Consistency assessment report

Proposed changes between Eaton Road, Luddenham
and Littlefields Road, Luddenham

**The Northern Road Upgrade – Mersey Road,
Bringelly to Glenmore Parkway, Glenmore Park**

December 2018

Figure 2-3 Comparison of SPIR/ Final EIS and refined design operational footprints

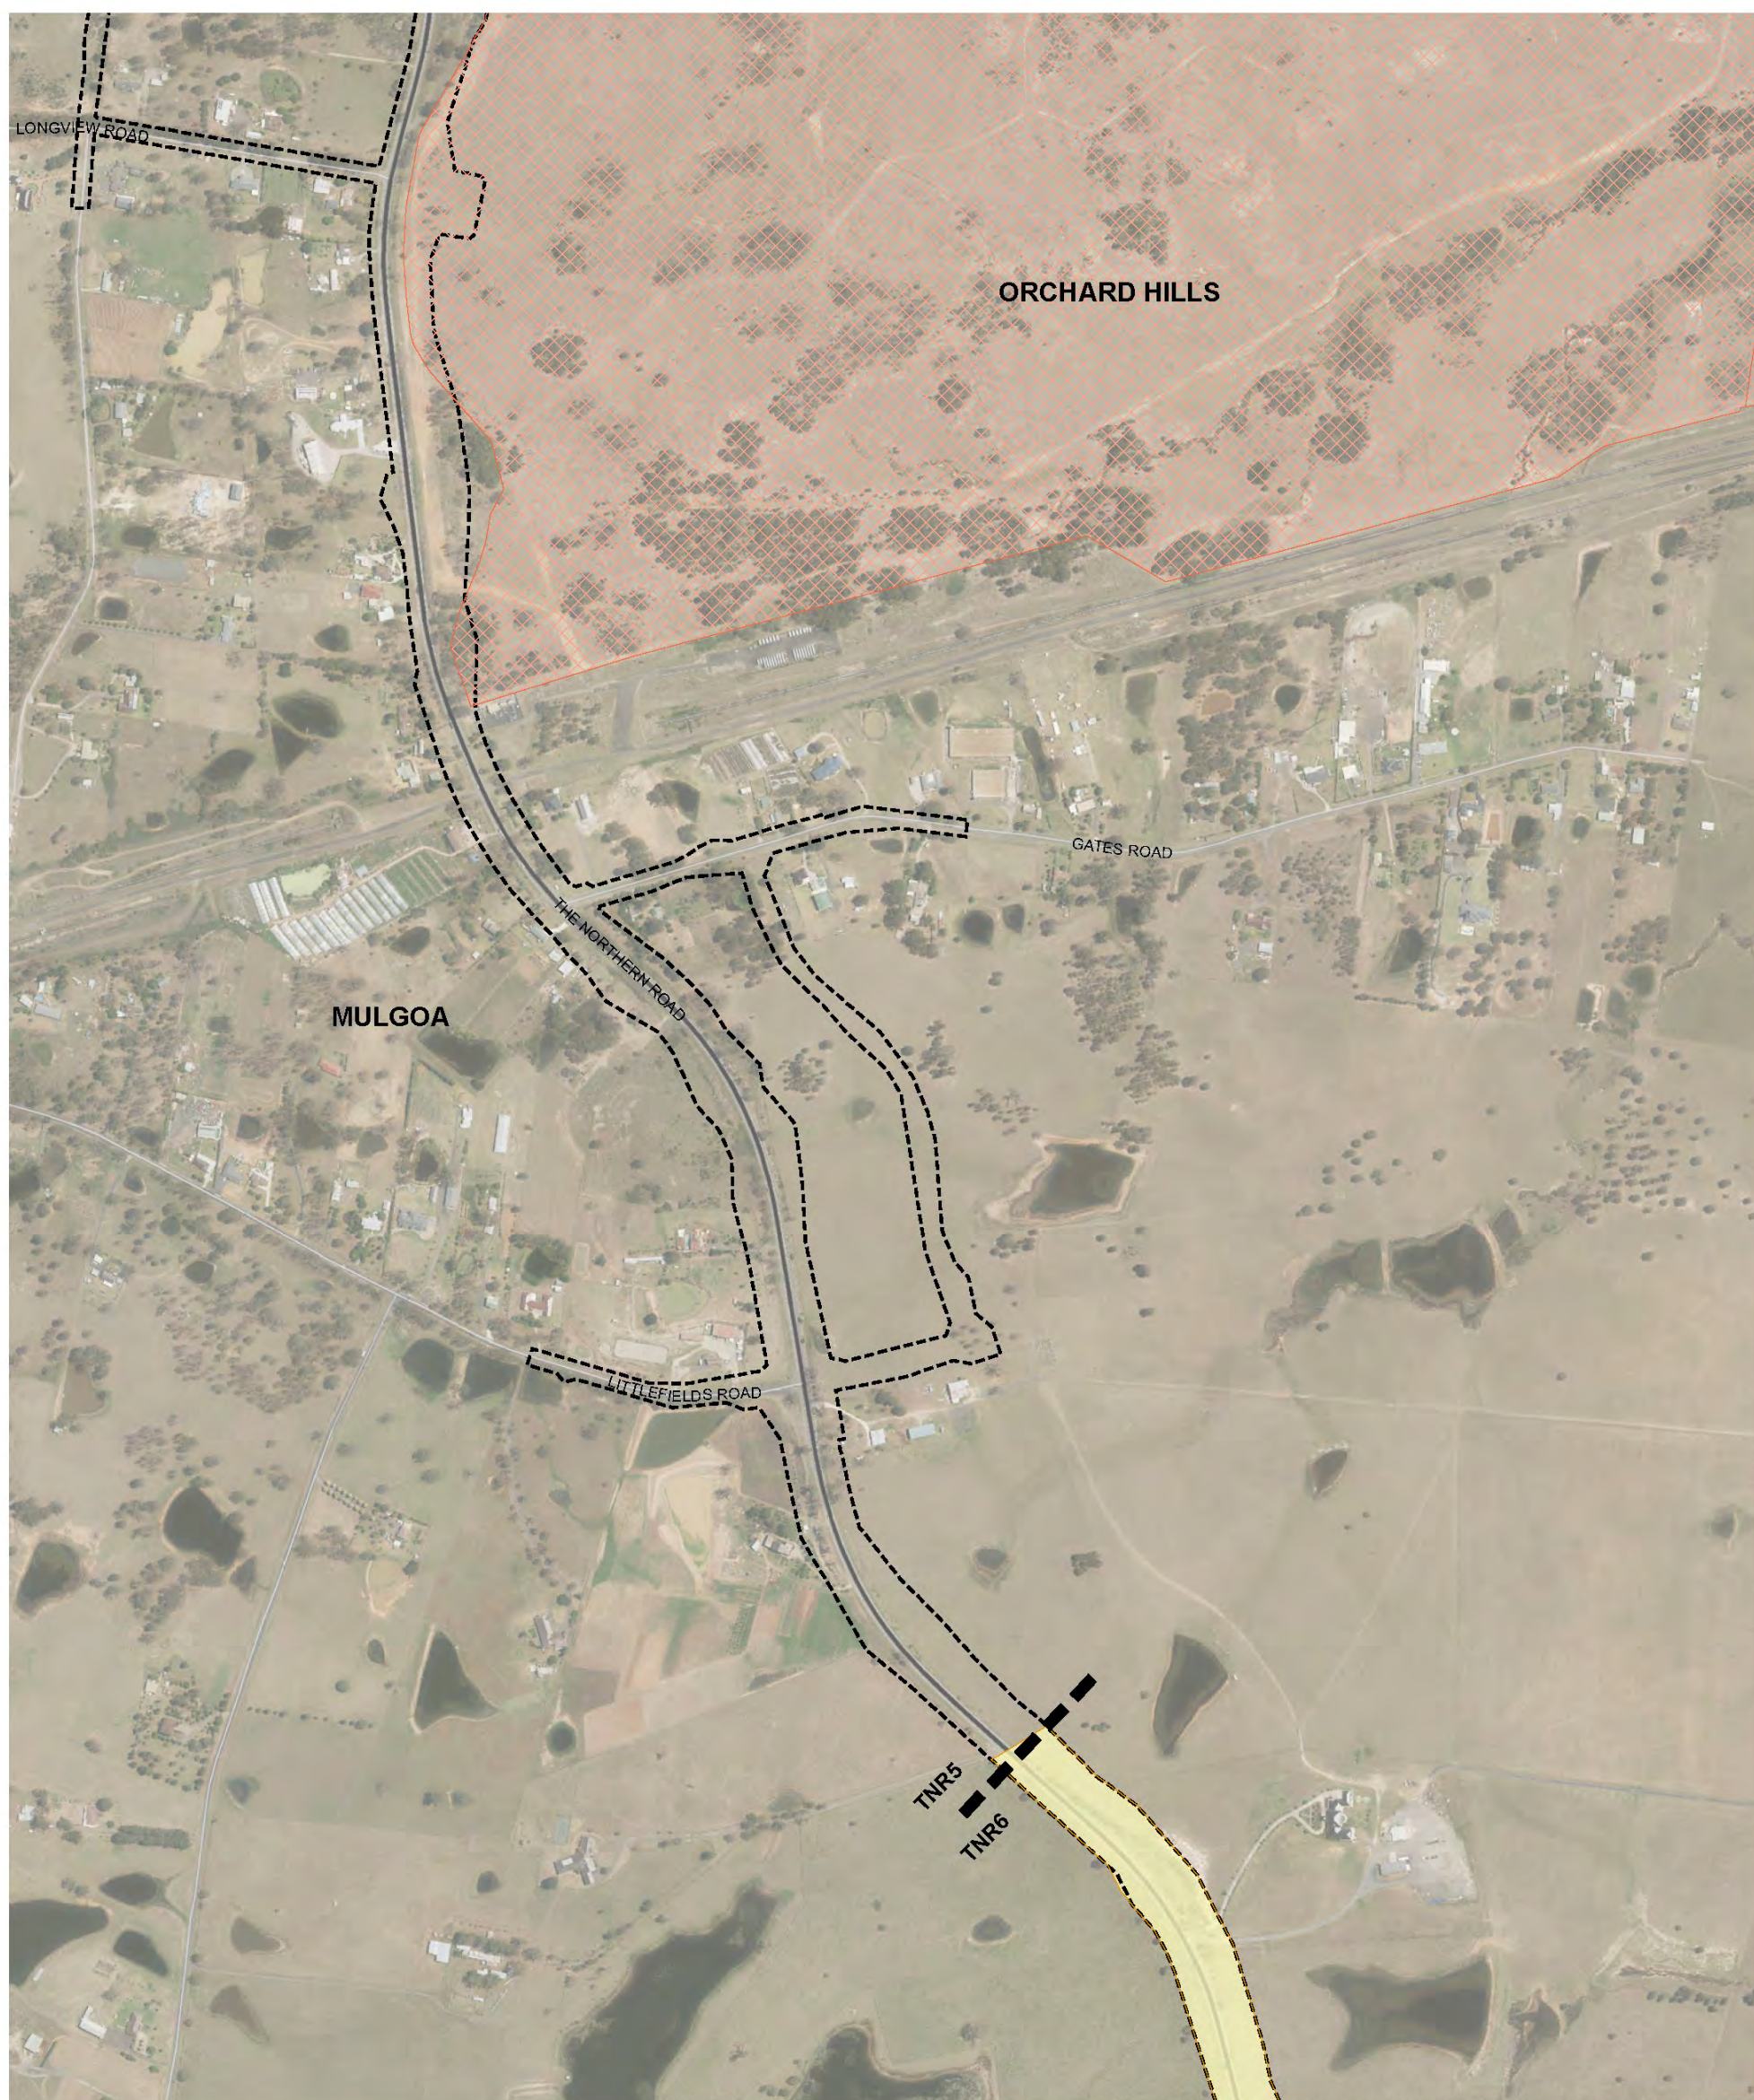
Proposed changes to the approved construction and operational project boundaries due to the proposed design changes are shown in Figure 2-2 and Figure 2-3 and are limited to:

- Minor increases to the construction boundary to allow private property access adjustments
- A reduced footprint for the ancillary facility area (and associated construction boundary) at the south-eastern corner of Elizabeth Drive and The Northern Road intersection
- Slight rationalisation (reduction) of the operational boundary at three locations based on the minor vertical, horizontal and cross-section alignment refinements proposed and consultation with affected property owners to reduce and simplify property acquisition.
- An increased construction and operational footprint around Adams Road to enable the regrading of this road (associated with the proposed modification).
